Recall Bulletin

SUBJECT: Power Steering Hose Routed Incorrectly

MODELS: 2012 Chevrolet Impala

GM Recall #11224

2696264

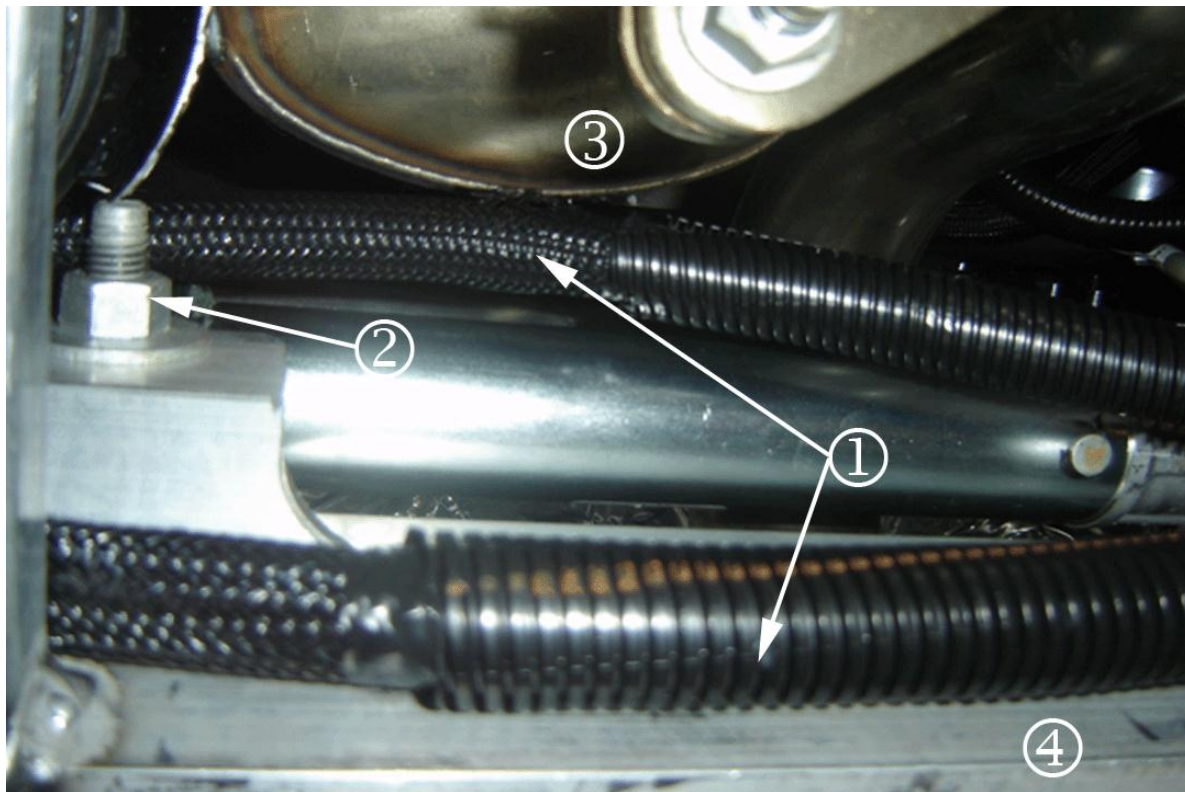
Correctly Routed Power Steering Gear Inlet Pipe/Hoses are Routed Below the Steering Gear Mount Bolt: (1) Power Steering Gear Inlet Pipe/Hose (2) Steering Gear Mount Bolt (3) Catalytic Converter (4) Cradle

- If the power steering gear inlet pipe/hoses are routed correctly, proceed to *Protective Sleeve Installation* in this bulletin.

2696265

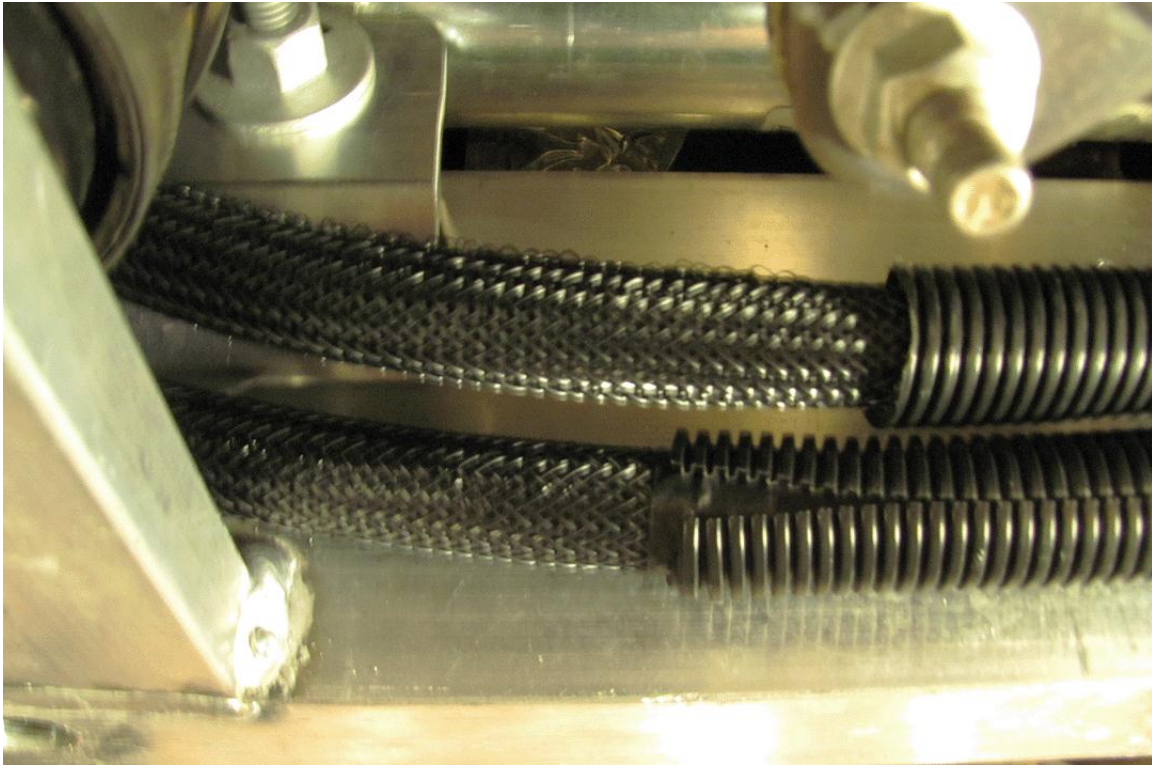
Incorrectly Routed Power Steering Gear Inlet Pipe/Hoses are Routed Above the Steering Gear Mount Bolt: (1) Power Steering Gear Inlet Pipe/Hose (2) Steering Gear Mount Bolt (3) Catalytic Converter (4) Cradle

Note: Incorrectly routed power steering gear inlet pipe/hoses include one or both hoses routed above the steering gear bolt. The hoses may contact the steering gear bolt and/or the catalytic converter. **REPLACE** the power steering gear inlet pipe/hoses if the hoses are incorrectly routed.

Note: A new single hose design replaces the older dual hose design. If a new single hose design is used, the protective sleeves are already included and *Protective Sleeve Installation* procedure in this bulletin is not required..

- If the power steering gear inlet pipe/hoses are NOT routed correctly, remove and replace the power steering gear inlet/pipe hoses. Refer to *Power Steering Gear Inlet Pipe/Hose Replacement* in SI. After installing the power steering gear inlet pipe/hoses, ensure that the hoses are routed below the steering gear mount bolt. Refer to *Correctly Routed Power Steering Gear Inlet Pipe/Hose* illustration. Proceed to *Protective Sleeve Installation* in this bulletin after installing the power steering gear inlet pipe/hoses.
